POOL BARRIER PLAN

Project:	PROPOSED POOL, SPA & ALFRESCO
Client:	CANN
Site:	35 KEEL RETREAT, PORT GEOGRAPHE

Sheet title	**POOL BARRIER PLAN**
Date	3 Nov 2026
Revision	B
Scale	1:100

A3-03

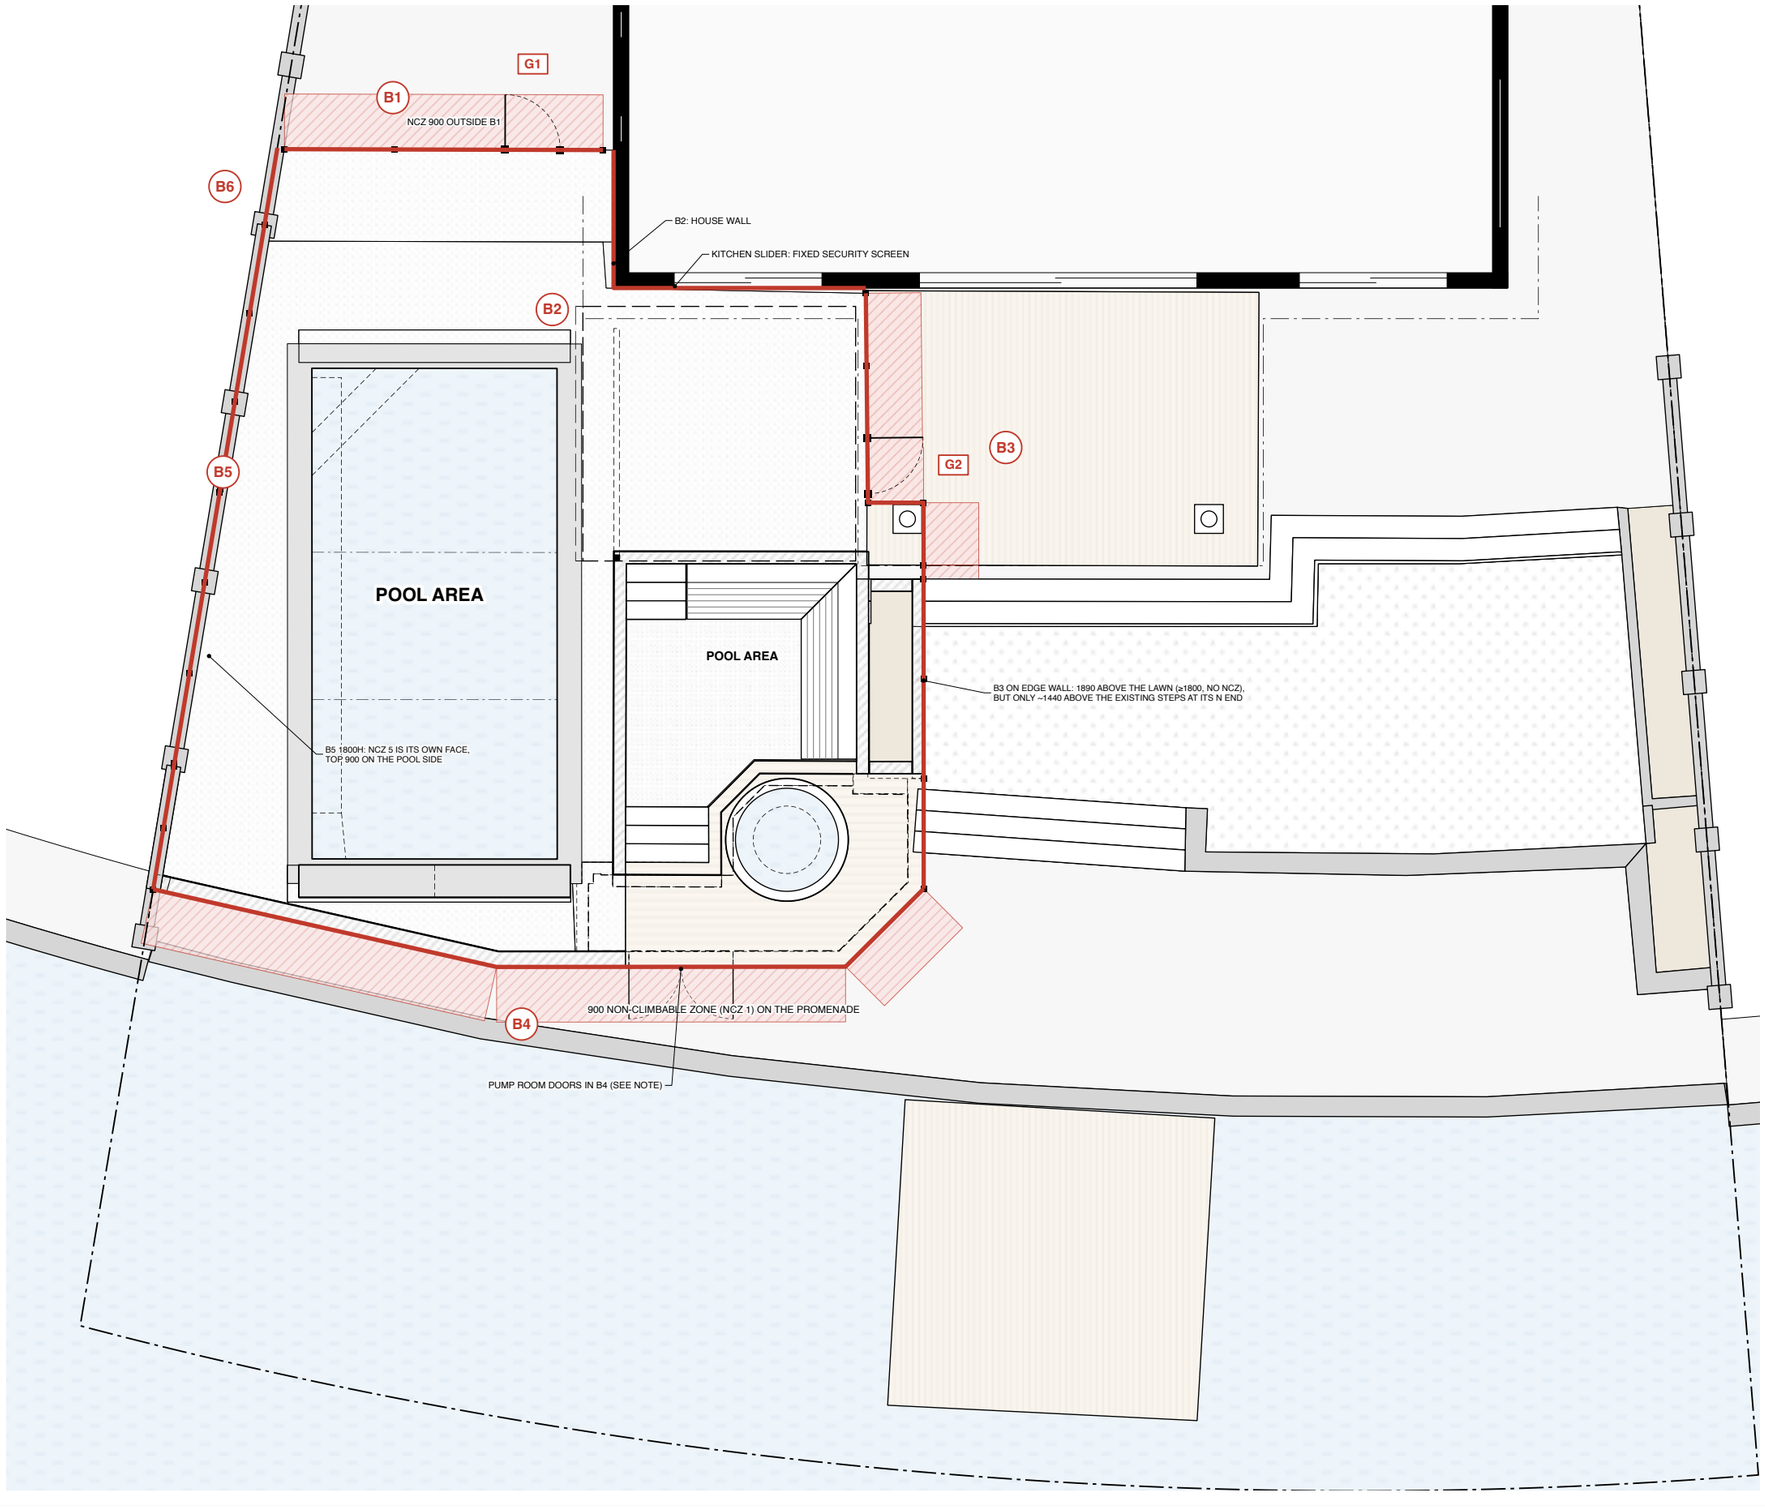
B2: the kitchen slider opens from the house into the pool area. A fixed security screen is to be fitted (estimate 7 Oct); SK02 also notes re-glazing it to pool requirements. Certifier to confirm.

B4: the retaining wall is the barrier on the canal side. Its face must stay smooth (no footholds). The pump room doors (1700 x 950) sit in it under the deck, opening out onto the promenade; the pump room has no opening into the pool area.

The pavilion's pillar is inside the fence, 28 from it.

TO CONFIRM WITH BOB

- B3 at its north end: only about 1440 above the existing lawn steps against it. OK as is?
- Pump room doors in B4, the canal-side barrier wall: their outside face must be non-climbable. Which door and finish?
- B1 and B3 stop 170 and 90 short of the house wall: close them up.
